Work Order ID 88434

Item Name: Crosstube Fwd High

DART AEROSPACE LTD		Work Order:	88434
Description: Crosstube High Fwd (205/212/412)		Part Number:	D212-664-101
Inspection Dwg: D212-664-141 Rev: D		Page 1 of 1

DRAWING NO. D212-664-141	TITLE XTUBE ASSY (205/212/412 HI FWD)	REV. D	DART AEROSPACE LTD ENGINEERING ORDER		D.E.O. NO. D212-664-141-D-1	SHEET NO. SHEET 1 OF 2	SCALE NTS
DRAWN	CHECKED	MFG. APPR.	APPROVED	DE APPR.			
DATE 11.04.07	DATE 11.04.11	DATE 11.04.12	DATE 11/04/12	DATE 11.04.12

**D212-664-141/-141B
ASSEMBLY DETAIL**

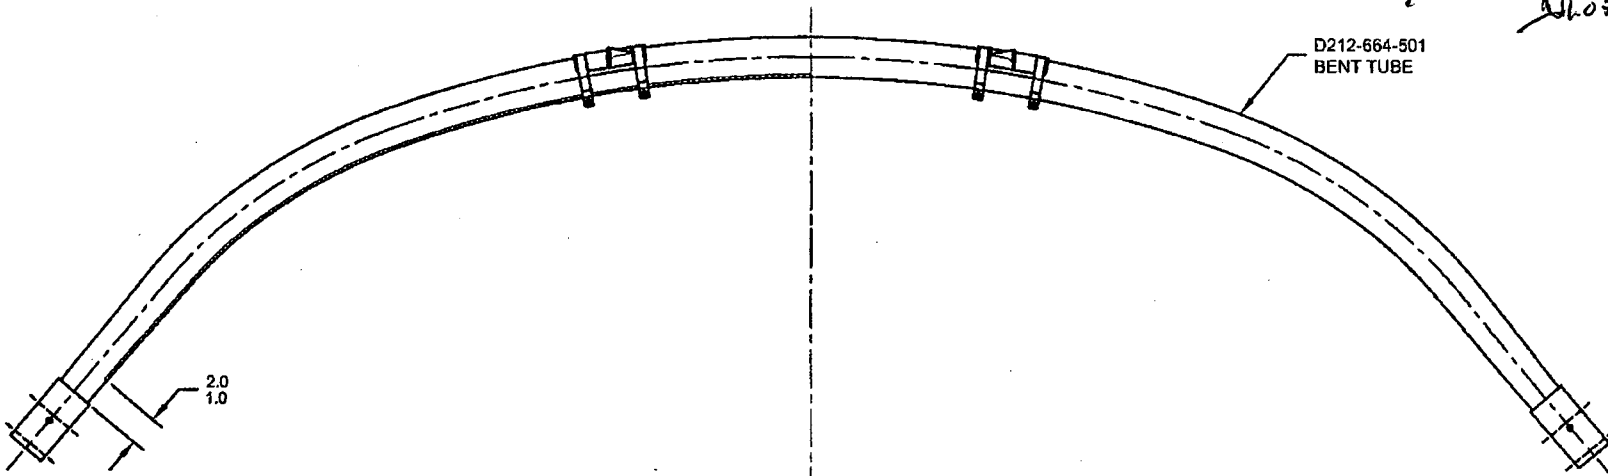
ADD AN INSPECTION WINDOW TO UNDERSIDE OF CROSSTUBE.

NOTES 2 OF SHEET 1 IS AMENDED AS FOLLOWS:

- 2) FINISH: CHEMICAL CONVERSION COAT PER DART QSI 005 4.1
PRIME INSIDE AND OUTSIDE PER DART QSI 005 4.2
MASK UNDERSIDE OF CROSSTUBE AS SHOWN (HATCHED AREA) AND
PAINT OUTSIDE PER DART QSI 005 4.2
REMOVE MASKING AND APPLY CLEAR COAT

- 2) FINISH: CHEMICAL CONVERSION COAT PER DART QSI 005 4.1
PRIME INSIDE AND OUTSIDE PER DART QSI 005 4.2
PAINT OUTSIDE PER DART QSI 005 4.2

MASK AREA PRIOR TO PAINTING,
REMOVE MASKING AFTER PAINT
AND APPLY CLEAR COAT
